Application for Licence Amendment

Licence Number	L7750/2001/10
Licence Holder	Evolution Mining (Mungari) Pty Ltd
ACN	002 124 745
File Number	2011/009482-1~7
Premises	Mungari Gold Project COOLGARDIE WA 6429 Legal description – Mining tenements M15/829 and M15/830 As defined by the Premises maps attached to the Revised Licence
Date of Report	6/10/2023
Proposed Decision	Revised licence granted

Figure 1: TRH Results for Oil Water Separators 2022 (AER)

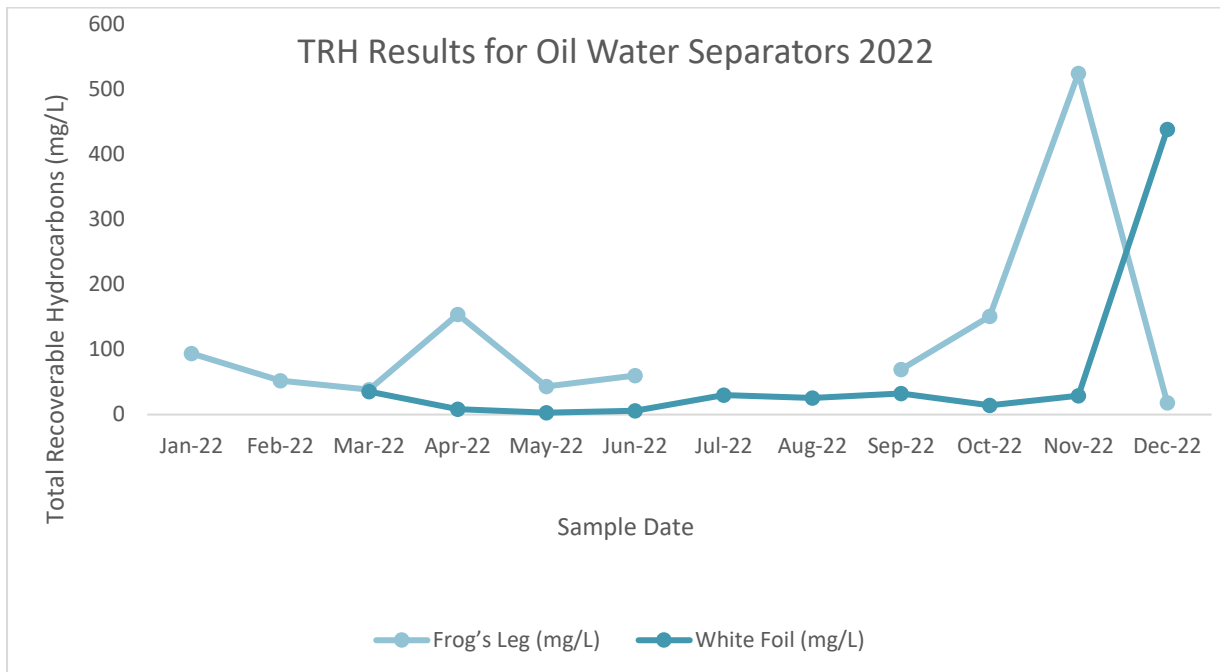
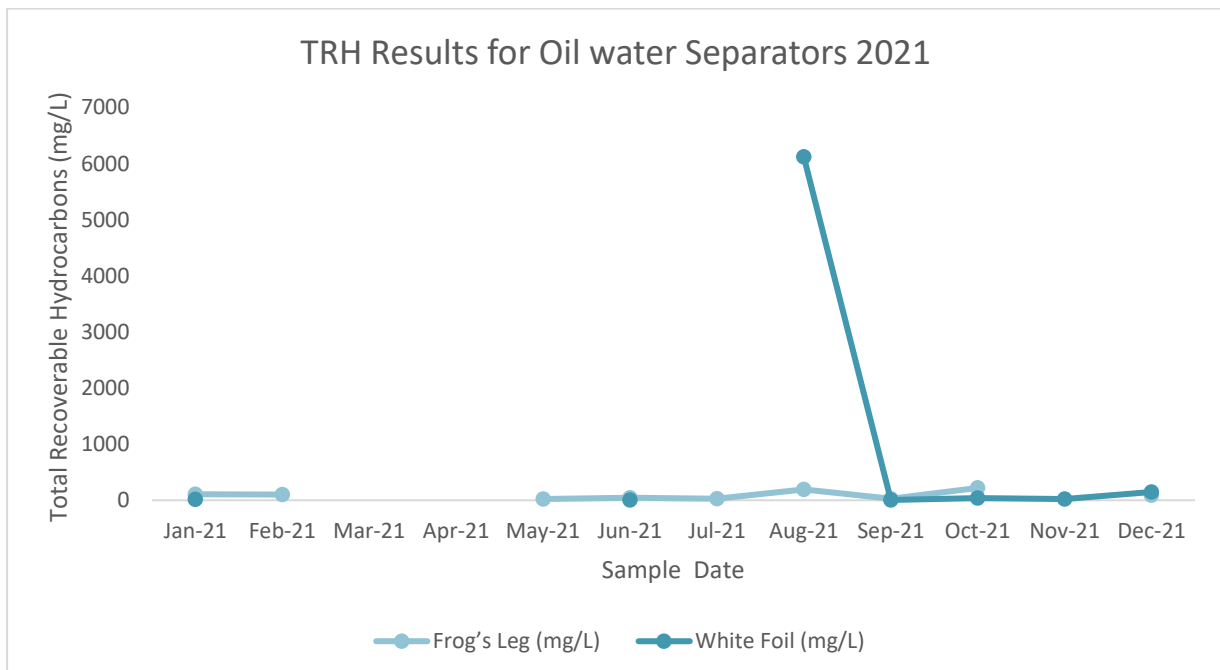
These Figures show significant exceedances in September 2021 and October to December 2022. This water was utilised for dust suppression within the Prescribed Premises Boundary. White Foil oil/water separator wastewater is disposed of offsite by a licensed controlled waste contractor.

Whilst the dilution was conditioned in the 2021 Licence amendment, no upper limit on the diluted groundwater (discharge water) was included. Due to the high levels of THR recorded since the 2021 amendment the Department believes there is potential for increased risk to the environment. In accordance with *Water Quality Protection Note 68 (WQPN 68)* (DWER 2013), as is standard practice for the discharge of treated wastewater to the environment, the Delegated Officer will take the opportunity to affect a DWER initiated amendment and will place an upper limit on the diluted wastewater to be discharged as per WQPN 68. Existing licence conditions 27, 28 and 29 specify annual reporting and non-compliance reporting requirements, including notification and investigation of non-compliance with any limits specified on the licence.

Condition no.	Proposed amendments
8	Inclusion of TSF Cell 3 (Stage 3) construction and Operating height.
20	Amended to include a 15mg/L limit on diluted water as per <i>Water Quality Protection Note 68</i>

Figure 4: TSF Cell 3 and 4 Standing Water Levels

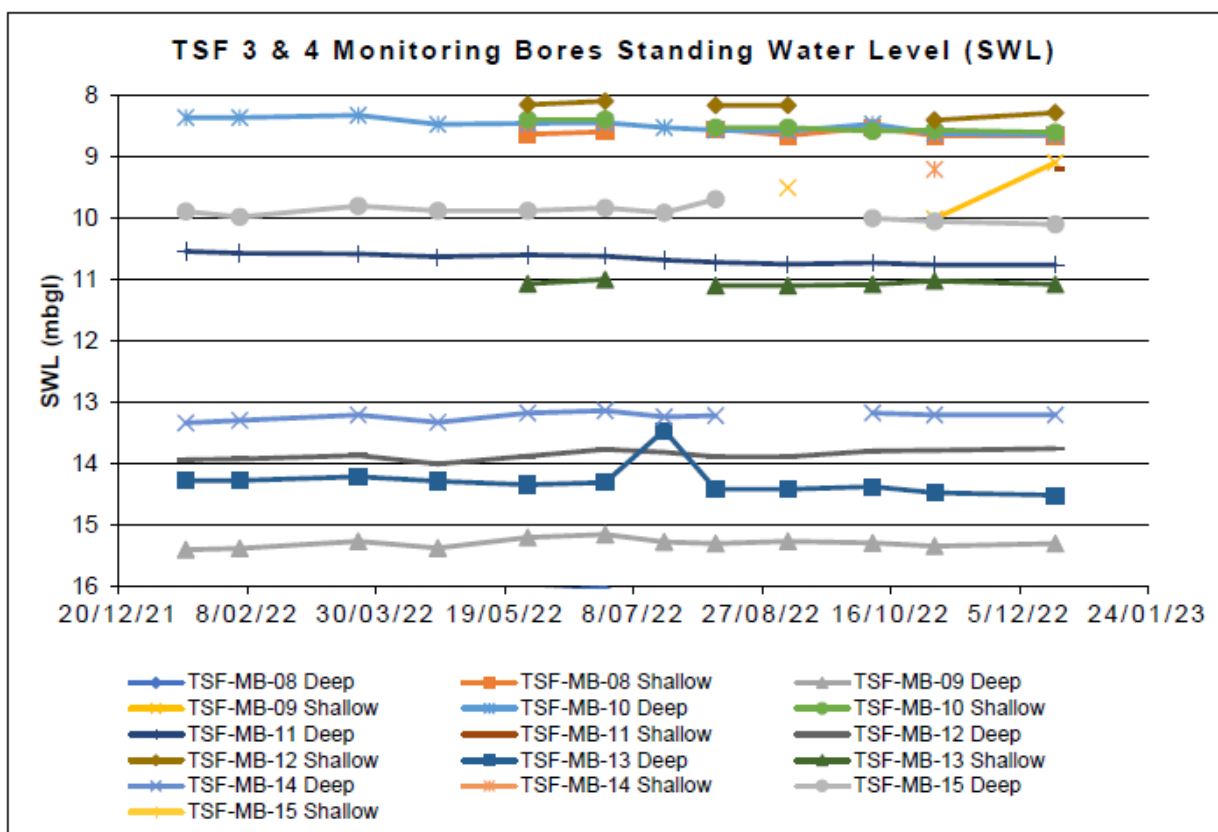
Standing Water Levels (SWLs) around the TSF Cell 3 have been recorded since the beginning of 2022. Water levels ranged from approximately 8 -14.5 mbgl and is summarised in Figure 4: **TSF Cell 3 and 4 Standing Water Levels**. Since commissioning, SWLs have remained stable surrounding TSF Cell 3 with some bores recording a slight decrease (Evolution Mining, 2023).
